Harron Homes

Land off Roslyn Avenue,
Netherton, Huddersfield

Stage 1 Road Safety Audit

CLIENT: Harron Homes
PROJECT TITLE: Land off Roslyn Avenue
 Netherton, Huddersfield
REPORT TITLE: Stage 1 Road Safety Audit
PROJECT REFERENCE: 400187
DOCUMENT NUMBER: 001
ISSUE NUMBER: 01
DATE: March 2026

Marked Up Plan for the Stage 1 RSA

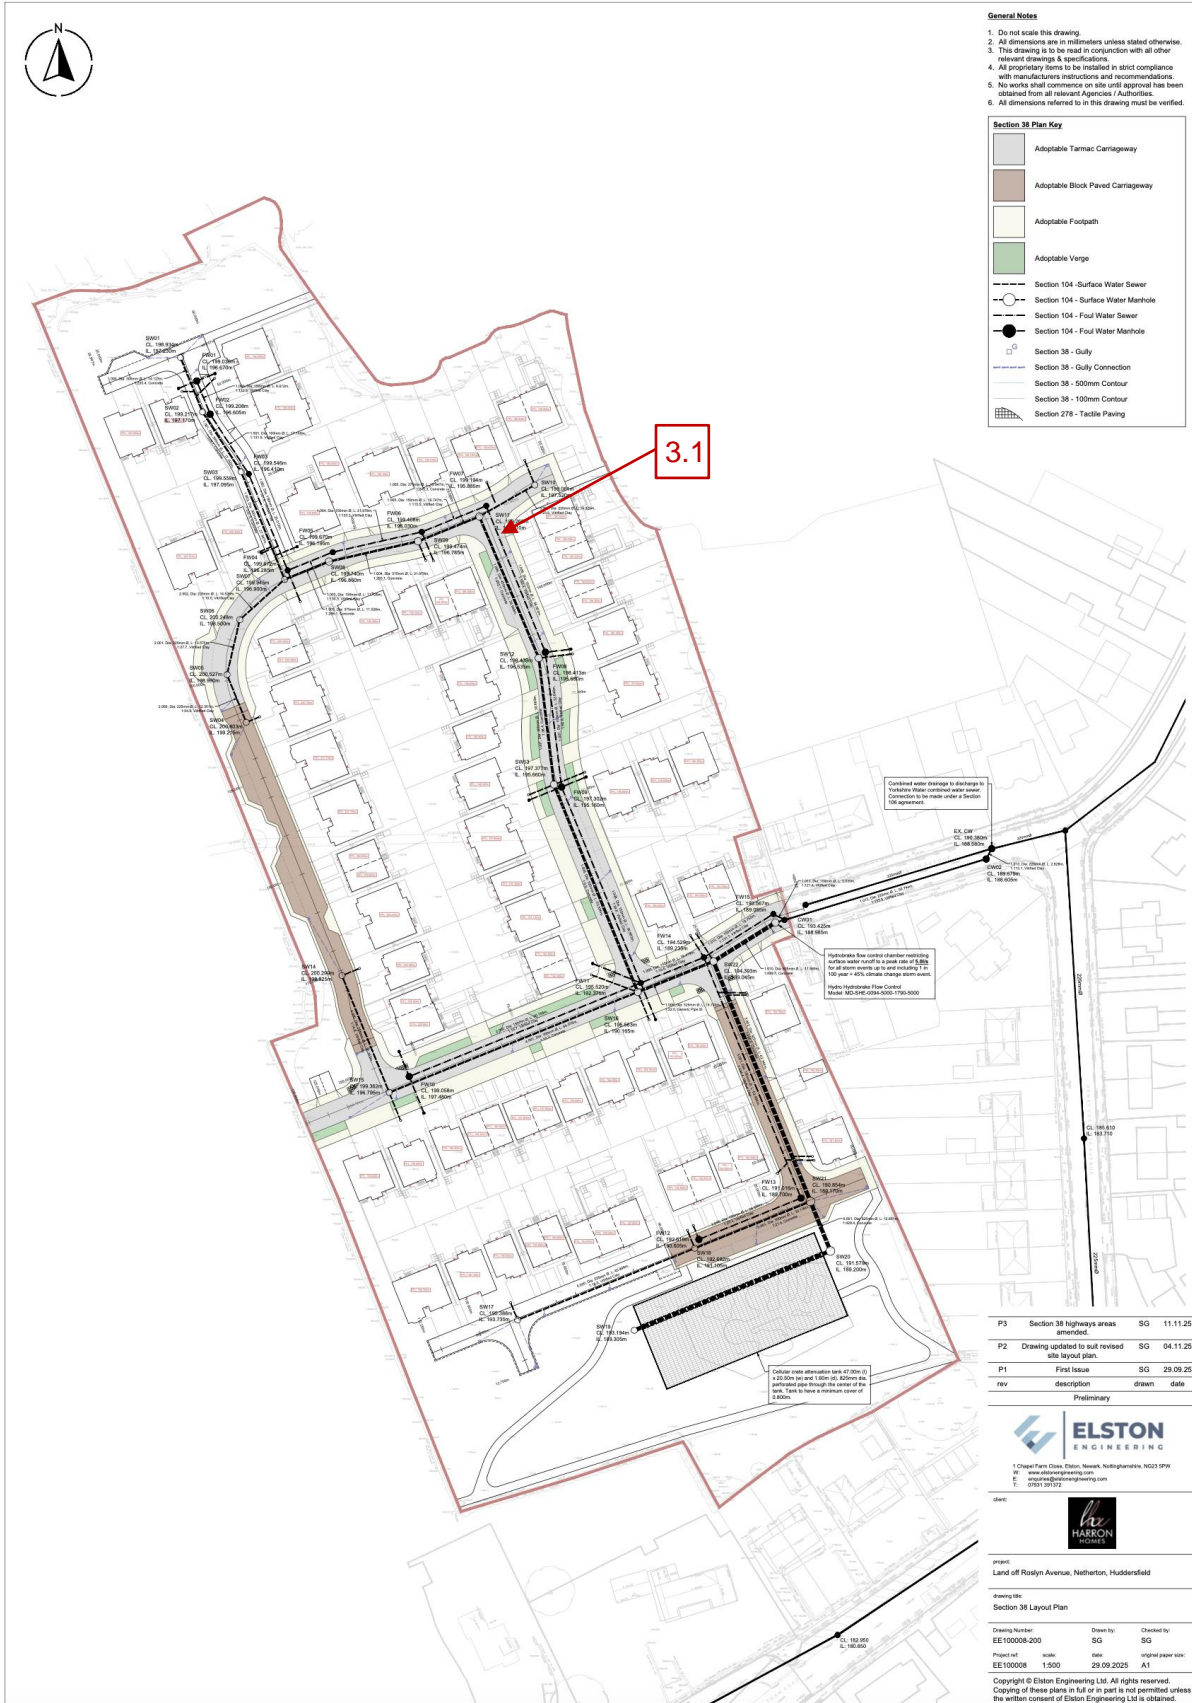
Problem 3.1:

Location: Junction adjacent to Plot 67.

Summary: Lack of dropped crossing.

Detail: Proposed dropped kerb pedestrian crossing facilities are indicated on the Section 38 Layout Plan at the majority of significant junctions within the development. However, no dropped crossing provision is shown at the junction located at the north-east end of the loop road. There is a footpath link to and from the development adjacent to Plot 67 that connects to this junction, which is likely to generate pedestrian movements across the carriageway at this location. The absence of a dropped crossing may therefore result in an inconsistent level of pedestrian provision and may create difficulties for mobility-impaired users, wheelchair users, and those with pushchairs attempting to cross the carriageway. This may discourage pedestrians from using the footway network as intended or lead to informal crossing at locations without appropriate tactile paving or level access.

Recommendation: It is recommended that a dropped kerb pedestrian crossing point be included in the design at this junction including appropriate tactile paving.
